# 630 The East Mall-

## Response to Transportation Issues

**TO:** Barry Horosko (Horosko Planning Law)  
**FROM:** Sharon Sterling RPP, MCIP, and Ken Wimble, P.Eng. {MB}, (WSP)  
**SUBJECT:** 630 The East Mall – Response to City of Toronto Transportation Issues  
**DATE:** June 6, 2024

Drawing No.:  
**A 1.01a**

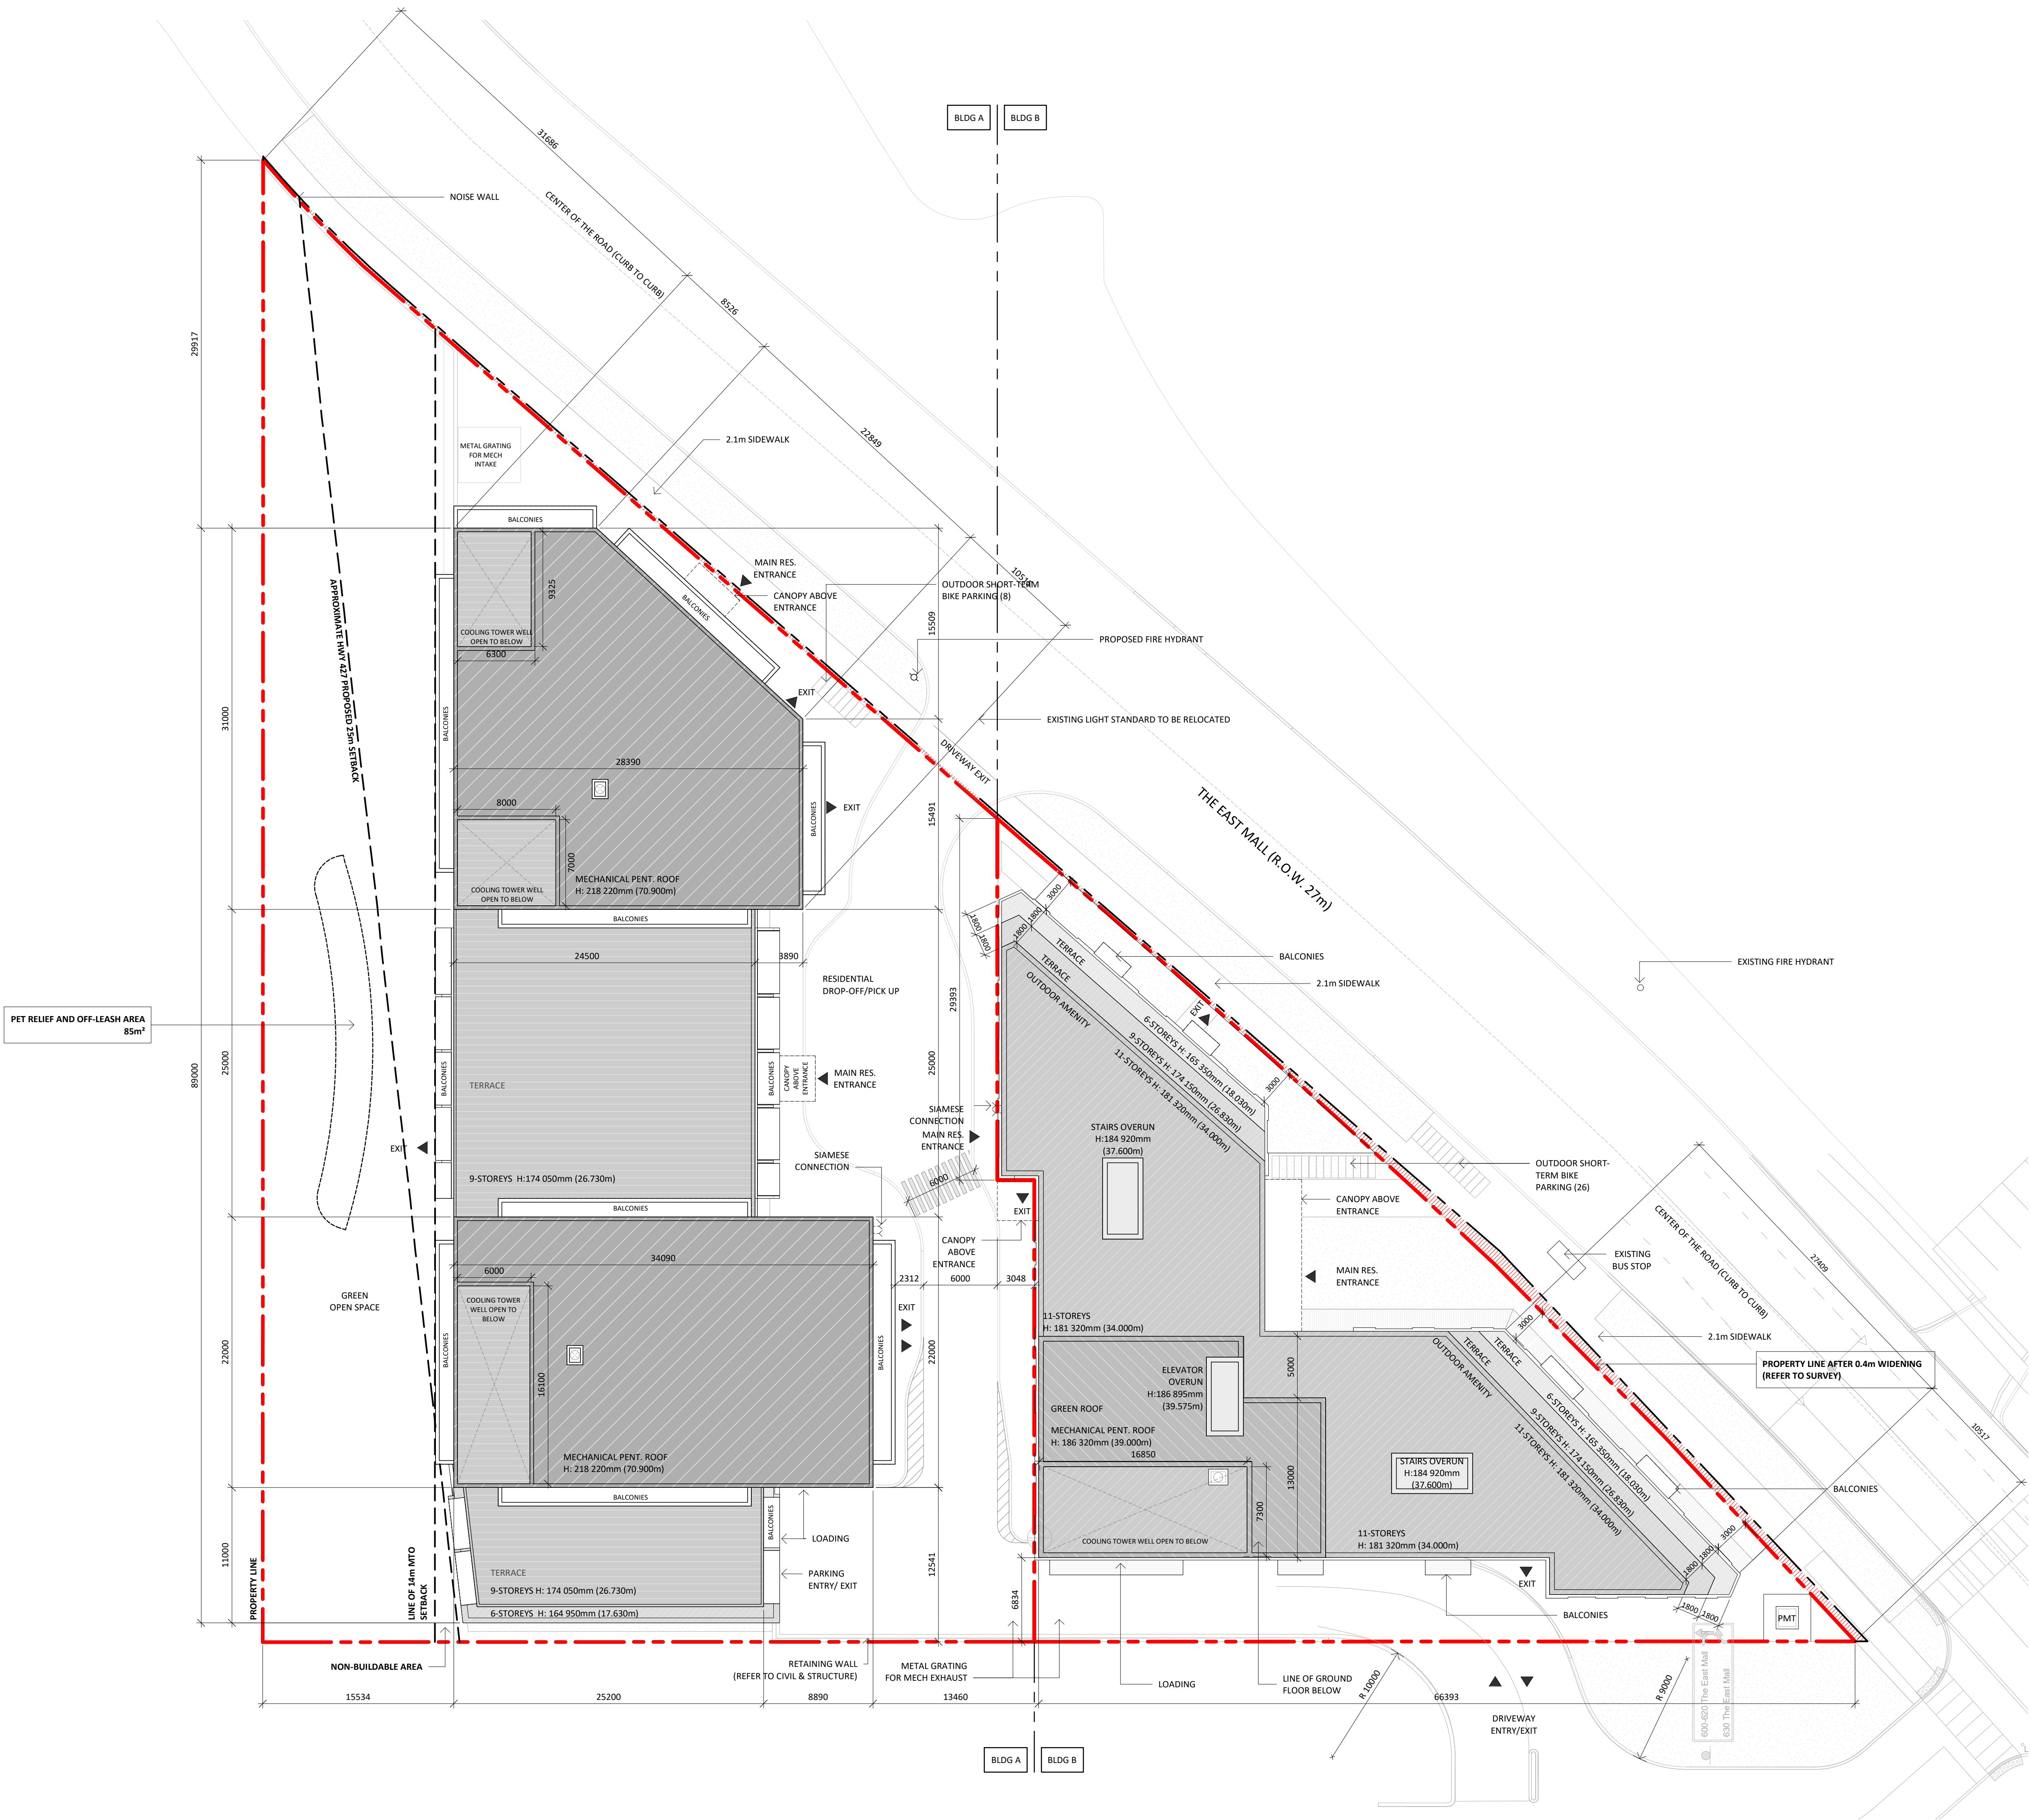
The applicant has considered the City's request and has developed a proposal to provide a right-in / right-out north access for the Ultimate access configuration, as illustrated in **Attachment C Figure 13**, instead of the all-directional access proposed in previous development submissions to the City. The access consists of 4m wide entry and exit lanes, which are expanded to 6m wide with mountable curbs and aprons to accommodate fire trucks, as shown in **Attachment A**, the Architectural plan.

**Attachment C Figure 14** illustrates that typical passenger vehicles can enter and exit the site without obstructions and be visible to pedestrians walking along The East Mall. Fire service access to Site A residential towers and Site B mid-rise is via the internal pick-up/drop-off area shown in the architectural plan in **Attachment A**. Fire trucks can park in this area and be within the required 15m from building entrances, as shown in **Attachment C Figure 15**. **Attachment C Figure 16** illustrates the fire truck exiting the site driveway.

FIGURE 1  
Site Dimensions - Ground Floor  
630 The East Mall

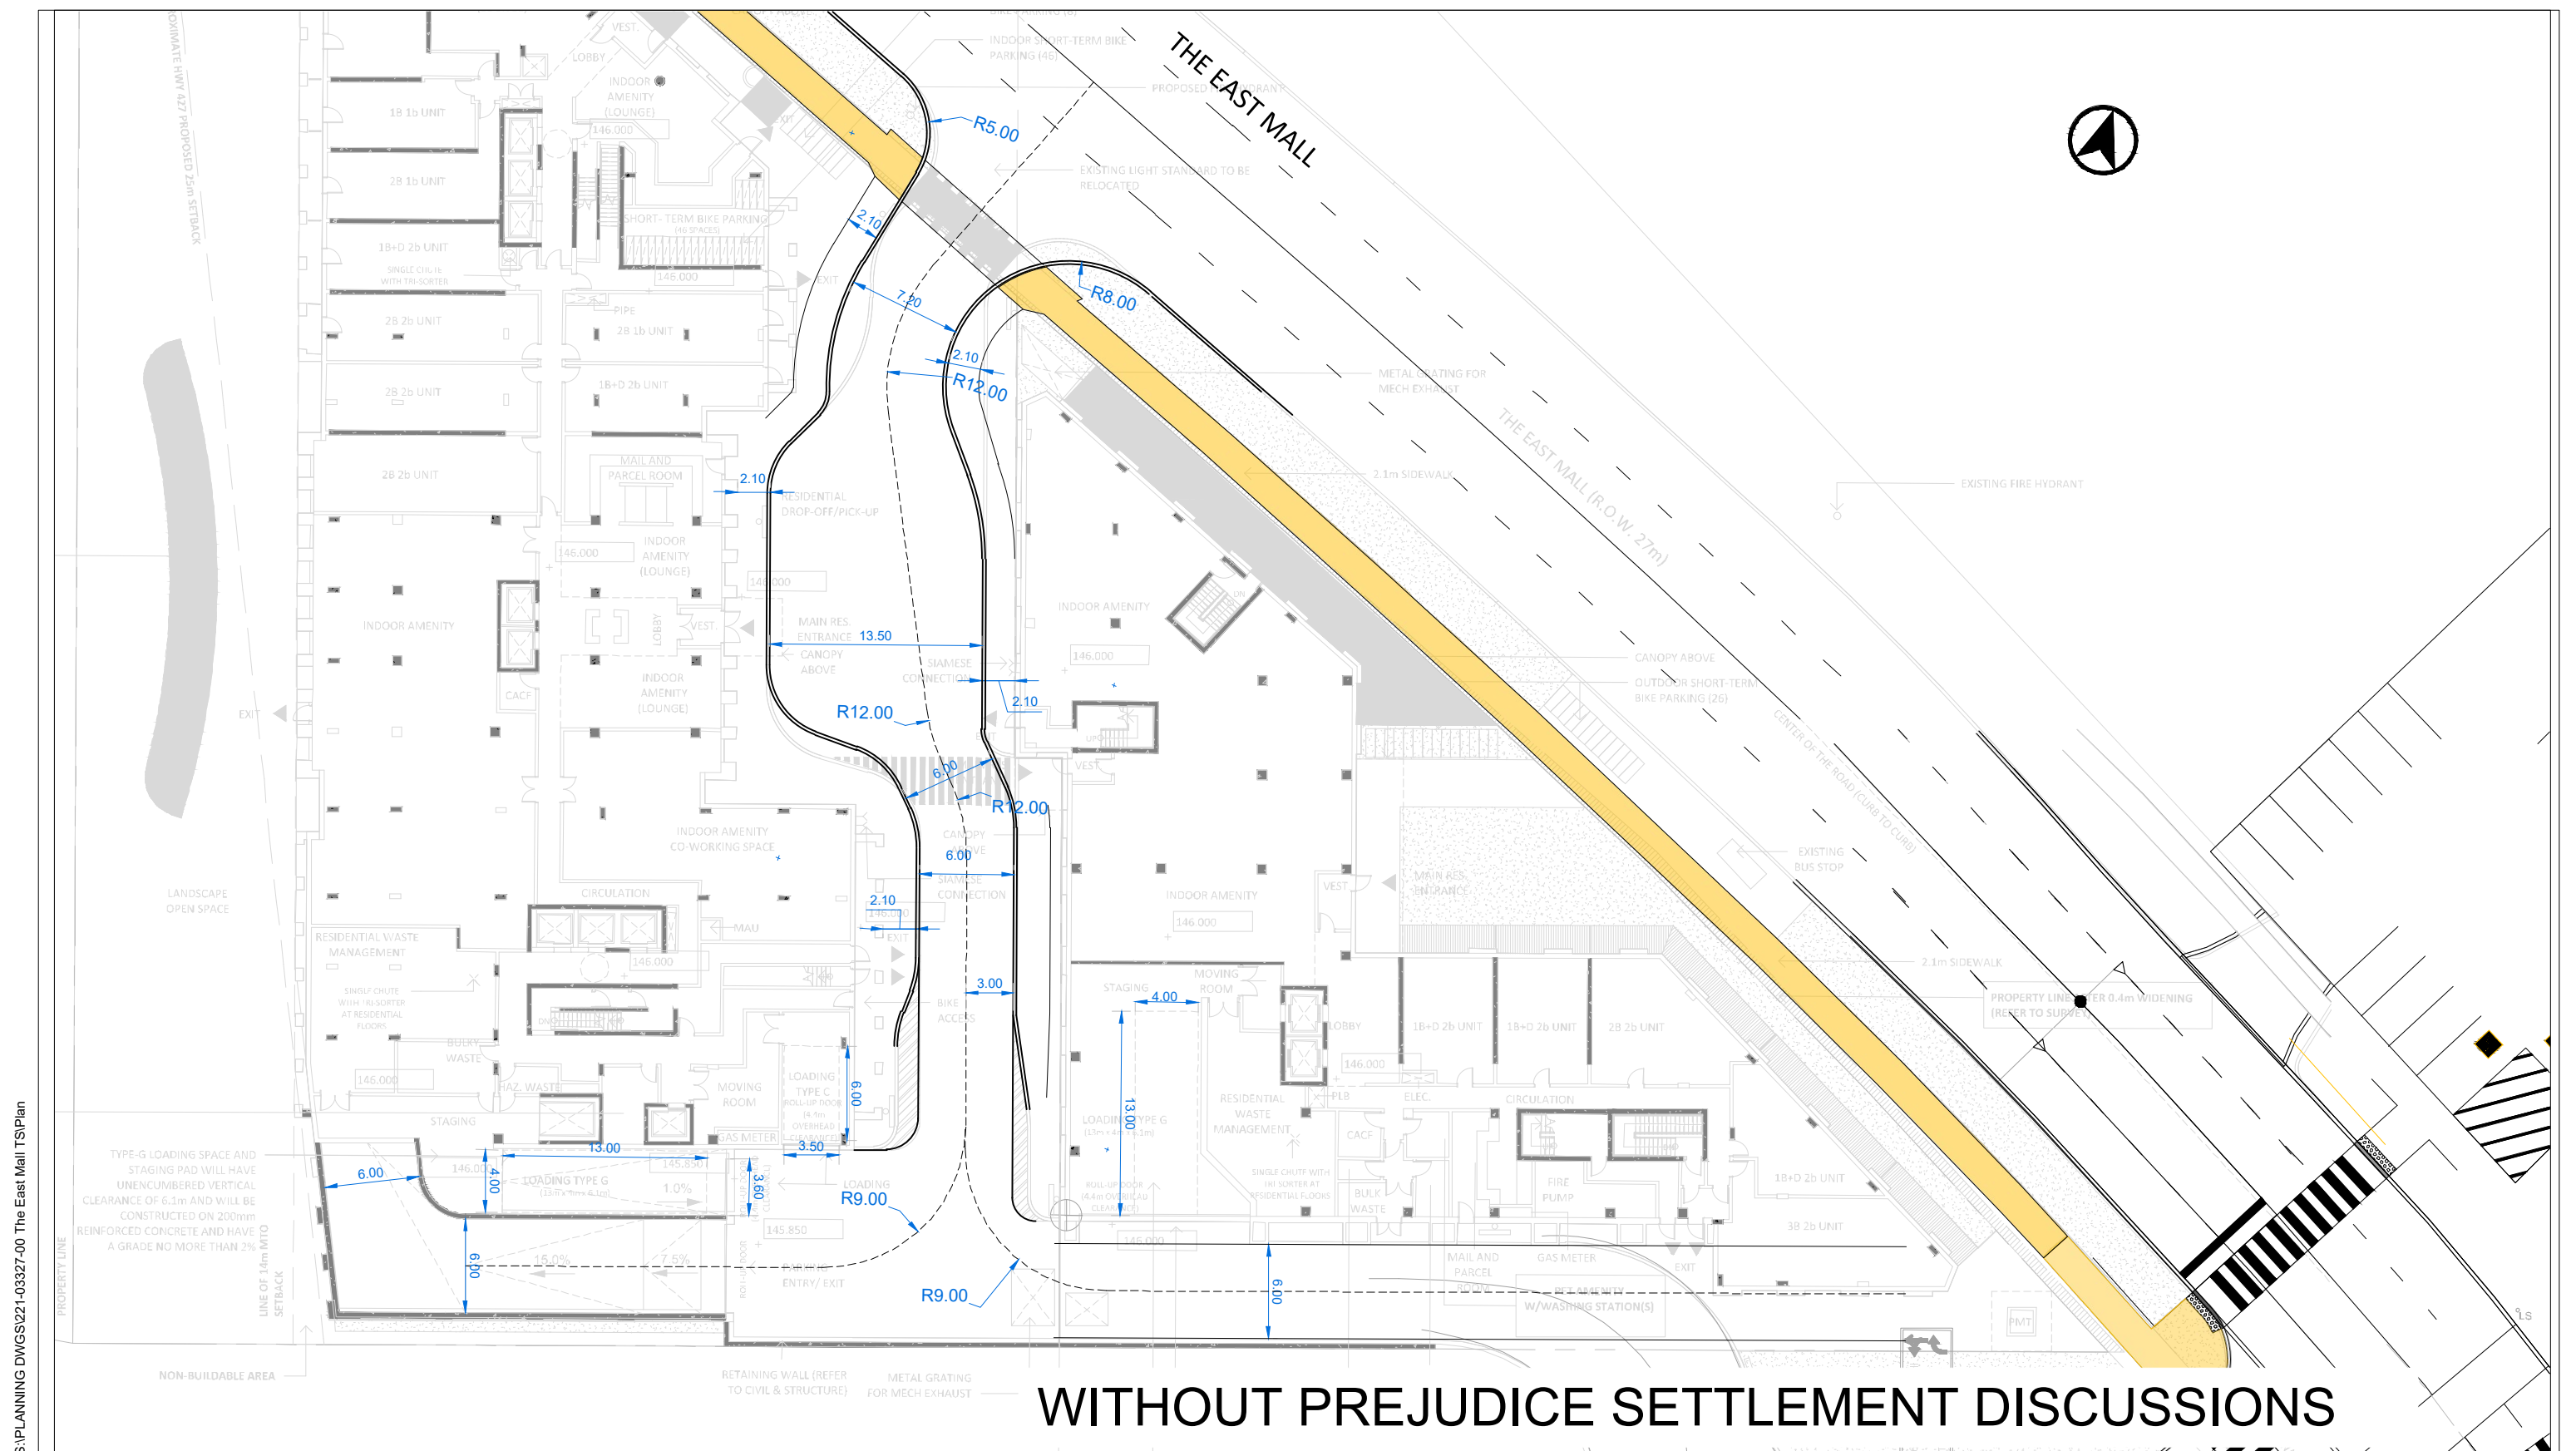
The dimensions of the proposed interim all-directional unsignalized north access are provided in **Attachment B Figure 1**. The access features a 5.0m inbound radius to encourage slower vehicle speeds at the pedestrian crossing. An 8.0m radius is provided for the outbound radius to provide additional manoeuvring space for commercial trucks and waste collection vehicles. The access width is 7.20m. These dimensions are consistent with City of Toronto Standard Drawing T-350.01.
